# INITIAL FIRE SAFETY INSPECTION REPORT

**Factory name: Rupa Fabrics Limited (Extension)**

**RSC ID: 24619**

**Date: 28 Nov 2023**

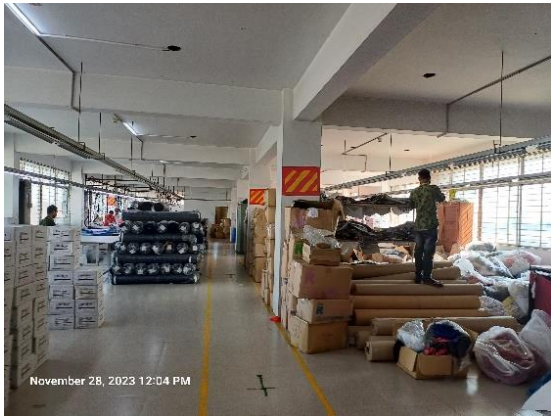
SI No.	Category	Findings	Required Action	Remediation Time Frame
1	Fire Rated Construction	<p>The exit stairs are not separated from work areas, other spaces on each floor by fire-rated construction due to the following reasons:</p> <ul style="list-style-type: none"> <li>i. Fire doors were not functional properly.</li> <li>ii. Unprotected opening was found due to toilet,</li> <li>iii. Shoe racks at the stairs.</li> </ul> <p>(7 Storied Building)</p>	<p>Provide minimum 1-hr rated doors for buildings with 3 or fewer stories and 1.5-hr fire rated doors for buildings that are 4 or more stories. Seal all unprotected openings to separate the exit stairs from work areas and other building spaces on all floor levels. Ensure that the fire doors are self-closing and positive latching and that they are provided with fire exit (panic) hardware where serving production floors. If fire doors are required to be held open for functional reasons, provide automatic closing devices tied to the fire alarm system. Once fire doors are installed, every door in a stair enclosure serving more than 5 stories shall be provided with re-entry unless it meets.</p>	Within 3 months

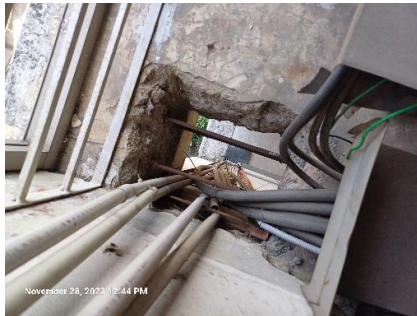
12	Fire Rated Construction	<p>Unsealed penetrations and openings are located in the fire-rated floor/ceiling assemblies.</p> <p>(Cable riser in Utility Building-2)</p>	<p>Provide a minimum 2-hr fire rated shaft to separate the utility risers from each floor level or seal all penetrations and openings in floors/ceiling assemblies by 3-hr fire rated listed/certified materials. The installation of such fire rated materials shall be following certified design.</p>	Within 3 months
----	-------------------------	----------------------------------------------------------------------------------------------------------------------------------------------	----------------------------------------------------------------------------------------------------------------------------------------------------------------------------------------------------------------------------------------------------------------------------------------------------------	-----------------

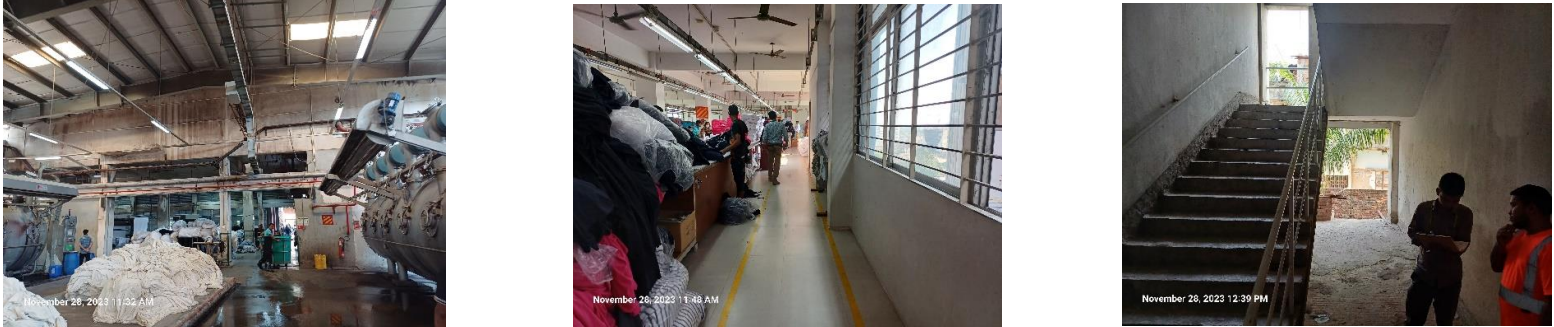
20	Means of Egress	Travel distance of egress exceeds limit on the dyeing Finishing Shed-3 ( found 52 m approximately).  (Dyeing Finishing Shed-3)	Reconfigure the egress arrangement or provide an additional exit so that the travel distance shall not exceed 23 m (75 ft).	Within 2 months
21	Means of egress	Electrical DB board found installed inside the exit stair enclosure-1.  (7 Storied Building)	Remove the DB board from the exit stair enclosure.	Within 1 month

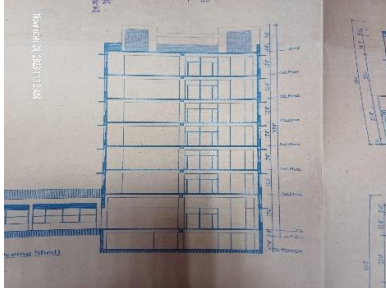
23	Emergency Lighting	<p>Exit signage and directional signs were not provided along a path of egress.</p> <p>(Dyeing Shed-2 &amp; Dyeing Finishing Shed-3)</p>	<p>Provide exit signs above all building exits to the exterior, all doors to the exit stairs; and illuminated directional signs shall be provided where there is a change in the direction for the path of travel and the direction to an exit is not obvious.</p>	Within 1 month
